# SAFETY RECALL: SERVICE BULLETIN 546 - HEATED GRIP SPACER

### **SAFETY RECALL: Service Bulletin 546 – Heated Grip Spacer**

<b>SERVICE BULLETIN 546: HEATED GRIP SPACER</b>		
<b>Bulletin Number</b>	<b>Models Affected</b>	<b>VIN Range</b>
546	Bonneville T120	From 739727 to 776237
	Bonneville T120 Black	From 741136 to 776237

1. Fixing
2. Handlebar end weight
3. Spacer
4. Handlebar
5. Heated twist grip

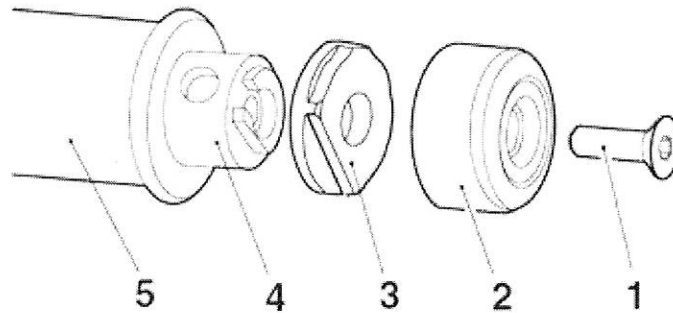
Triumph has released a Service Bulletin (SB546) with information on the need to add a new spacer between the end weight and handlebar on the right-hand side (throttle side) of Bonneville T120 & Bonneville T120 Black models in the affected VIN range. Motorcycles in the affected VIN range must be modified prior to delivery to the customer, or at the next visit to the dealership.

The addition of this new spacer (see Item 3 in diagram below) will ensure a sufficient expansion air-gap between the end of the throttle twist grip rubber and the end weight. The air-gap is required to accommodate the expansion of the rubber grip when the rider switches the heated grips to “on”. When turned “on” an insufficient air-gap may cause the (activated heated) throttle twist grip to bind on the end weight. Under these circumstances this may prevent the twist grip from returning to its positive stop without manual intervention by the rider. This symptom will not occur on a cold grip or models without heated grips.

All affected motorcycles are to be repaired in accordance with SB546. Please see attached **SB546 - Heated Twist Grip** PDF or visit the Service Bulletin library on **Triumphonline.net (TOL)** to access SB546, then print off the new bulletin for your workshop files and ensure all appropriate staff are made aware of contents.
